Re: Request for Spirit and Intent Letter
4311 Old Milford Mill Road, Baltimore, MD

PLAN TO ACCOMPANY
SPIRIT AND INTENT LETTER
4311 OLD MILFORD MILL ROAD

RE: 4311 Milford Mill Road
Zoning Case #89-527-A
3rd Election District

Re: Milford Mill Site
Shore Communications
Project No. 96011

PLAT TO ACCOMPANY VARIANCE APPLICATION:

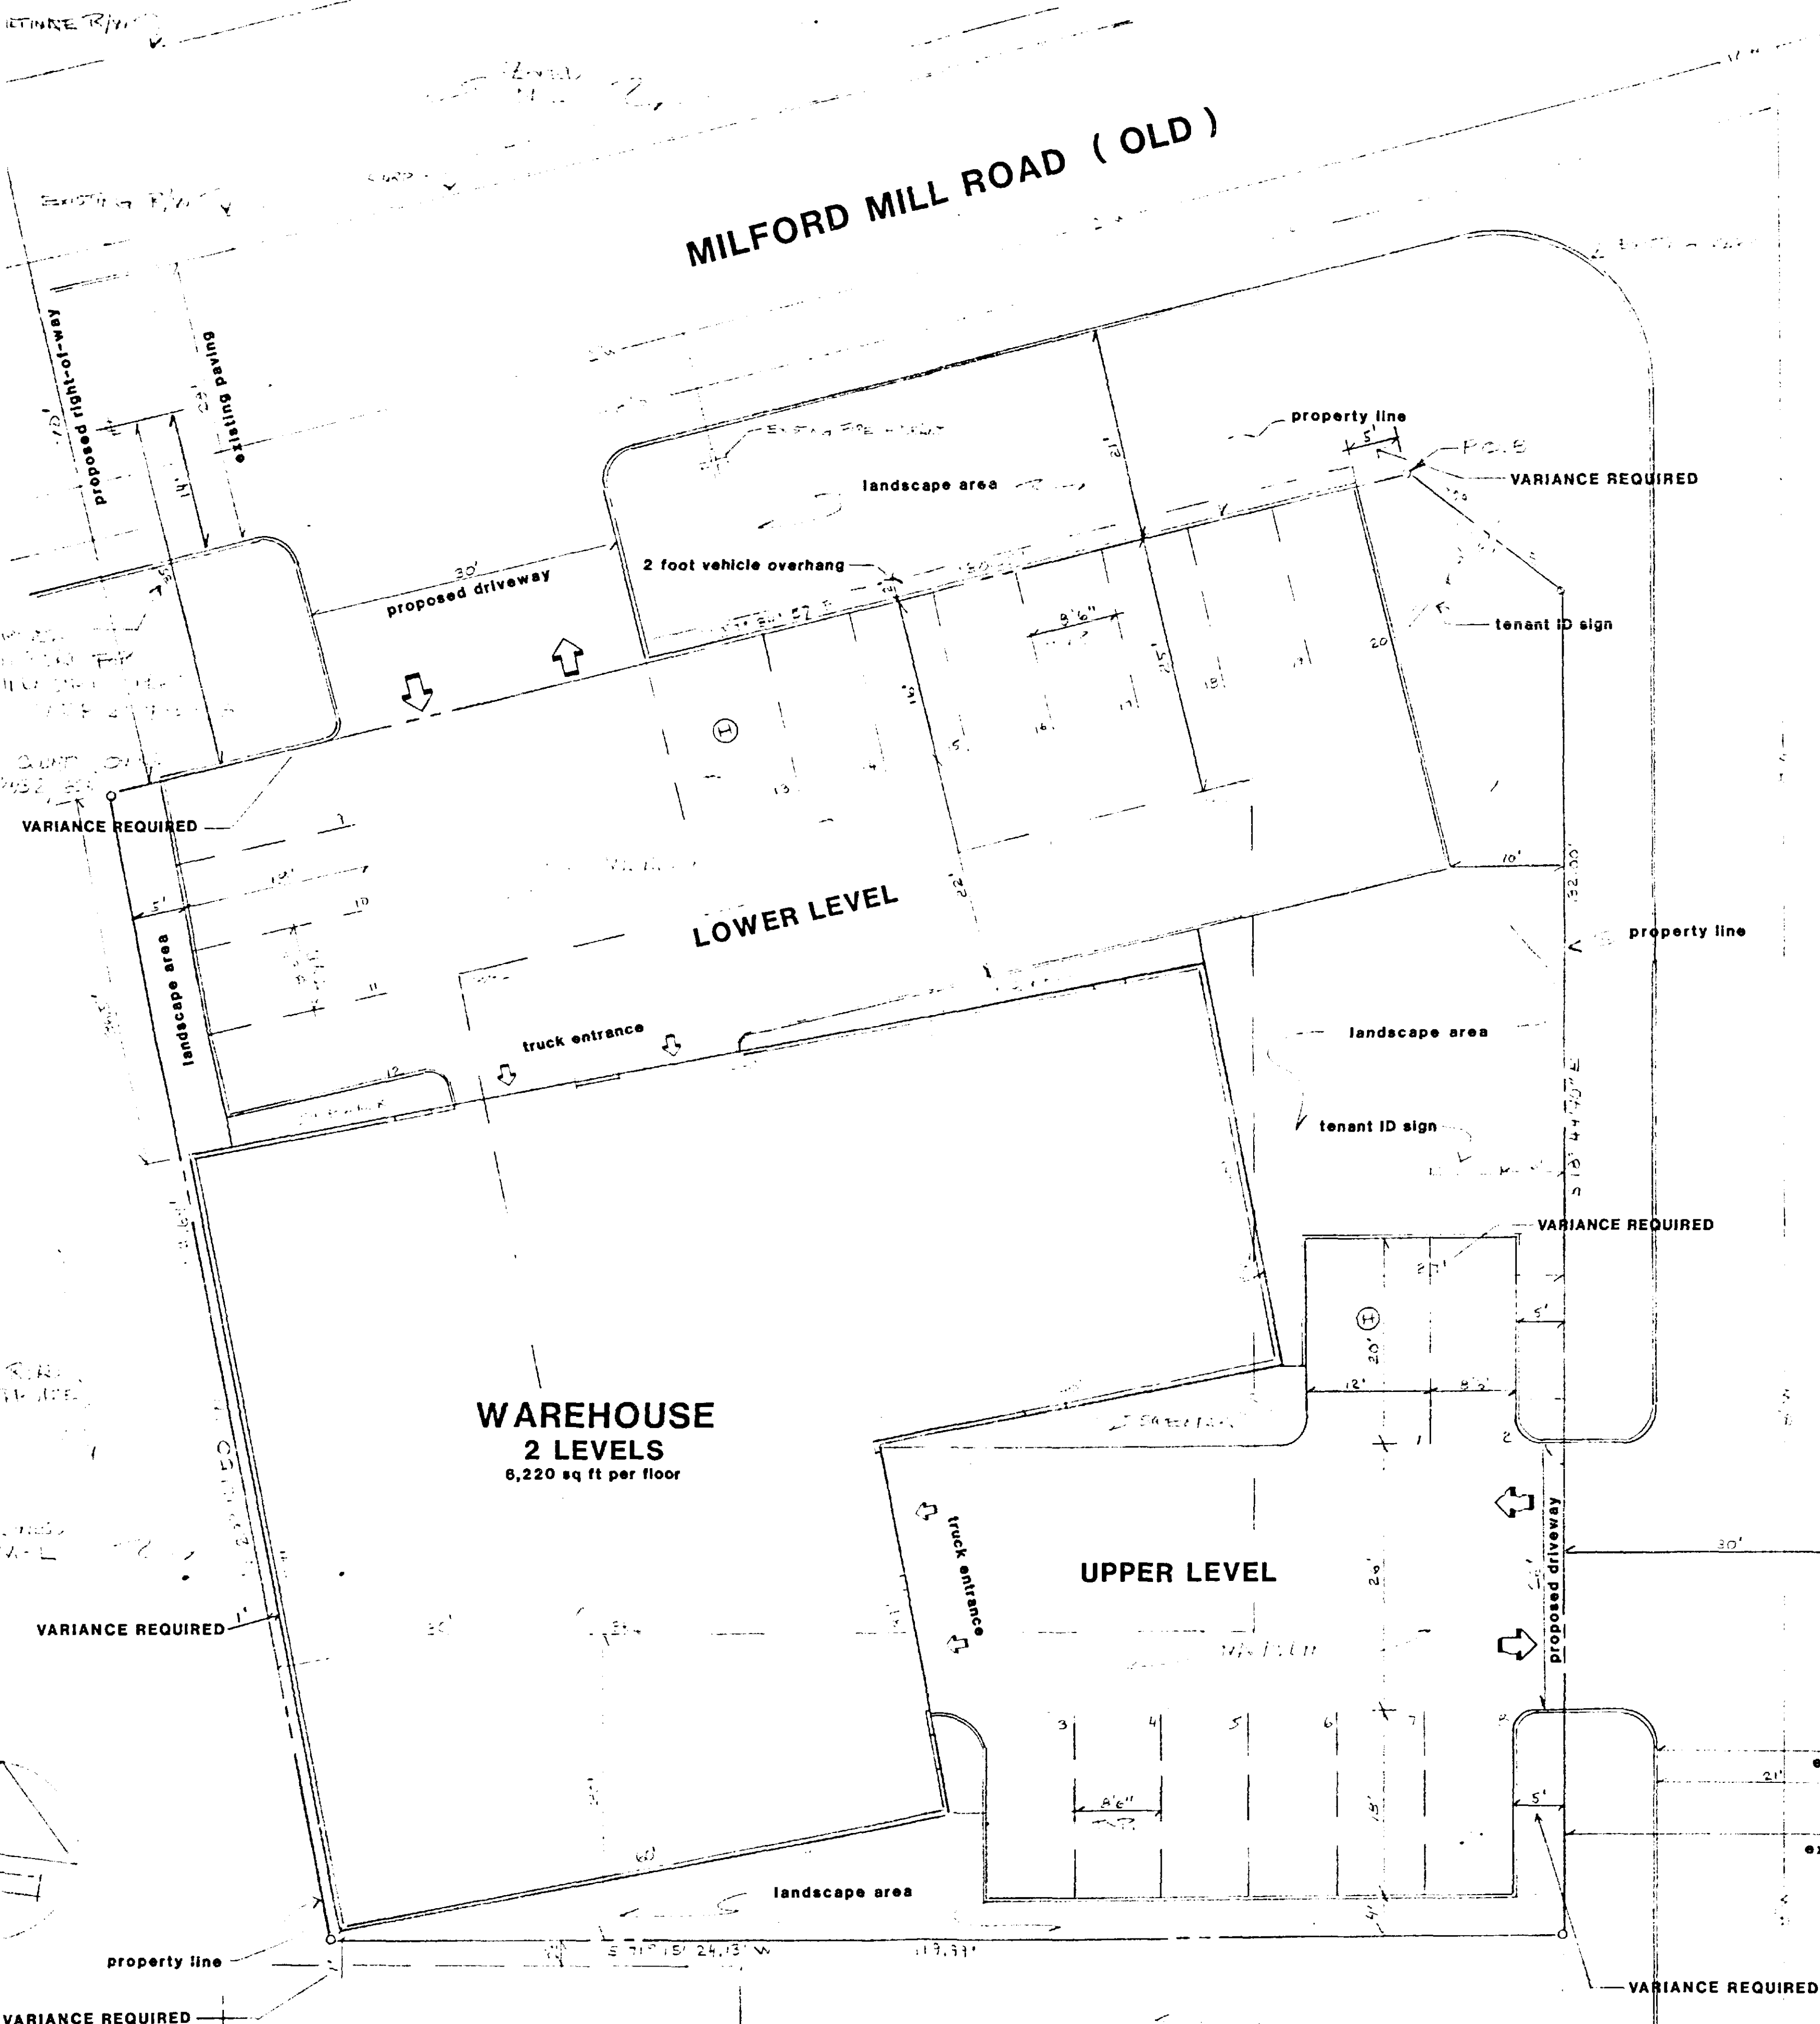
The requested parking setbacks create a conflict with Section IX.B.2 of the Landscape Manual, which requires a minimum 8 foot wide planting area along public streets. A modification of such standards may be requested in accordance with Section VIII of the Landscape Manual. This office would support a modification request provided that the 2 foot parking overhang is eliminated from the street right of way of Old Milford Mill Road. Wheel stops should be provided to prevent encroachment.
